UNITED STATES DEPARTMENT OF THE INTERIOR BUREAU OF LAND MANAGEMENT SUNDRY NOTICES AND REPORTS ON WELLS Do not use this form for proposals to drill or to re-enter a abandoned well. Use form 3160-3 (APD) for such proposa	NMOCD Artesia	FORM APPROVED OMB NO. 1004-0137 Expires: January 31, 2018 5. Lease Serial No. NMNM29233 6. If Indian, Allottee or Tribe Name
SUBMIT IN TRIPLICATE - Other instructions on page 2		7. If Unit or CA/Agreement, Name and/or No.

OXY USA Inc. - Current Federal 12 #6 API No. 30-015-26917

Temporary Abandonment of Wells on Federal Lands Conditions of Approval

Federal 12 6

7-7/8" hole @ 8525' 5-1/2" csg @ 8525' w/ 1375sx-TOC-2200'-CBL DVT @ 6176' OXY USA Inc. - Proposed Federal 12 #6 API No. 30-015-26917

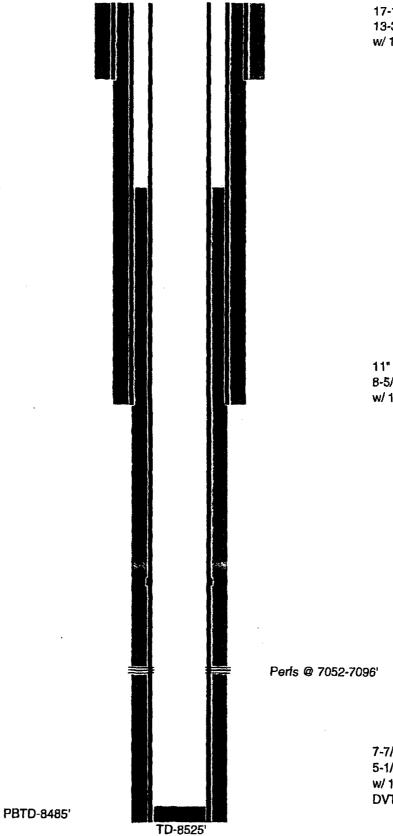
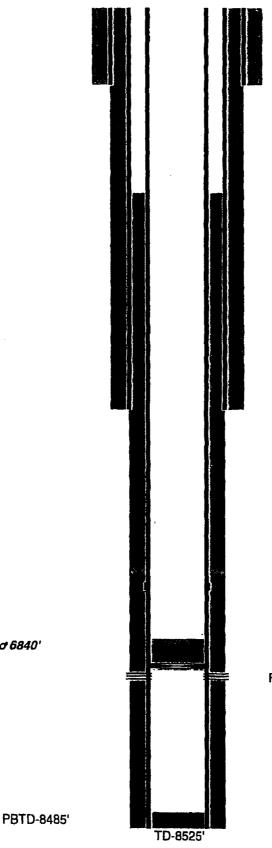
OXY USA Inc respectfully requests to temporarily abandon this well. It is currently being evaluated for possible future recompletion in the upper Brushy Canyon. An offsetting well is a currently completed in both the upper and lower Brushy Canyon. A program is currently being reviewed to do a water shut-off of the lower Brushy Canyon. If the results are good and economical, then this well is a future candidate.	•
economical, then this well is a future candidate.

ECEIVE		
 POOH w/ prod equipment, RIH & set CIBP @ +/- 7002' w/ 25sx cmt to 6840', WOC-Tag Notify BLM/NMOCD of casing integrity test 24hrs in advance. RU pump truck, circulate well with treated water, pressure test casing to 500# for 30 min. 	SEE ATTA	ACH	HP F(R	
/	CONDITIO	JNS	OF A	PPR	lov
14. I hereby certify that the foregoing is true and correct.				7

- 1. Well is approved to be TA/SI for a period of 12 months or until 10/26/2018
- 2. This will be the last TA approval for this well.
- 3. Must submit NOI to recomplete or NOI to P&A. Must be submitted by 10/26/2018
- 4. COA's met at this time.
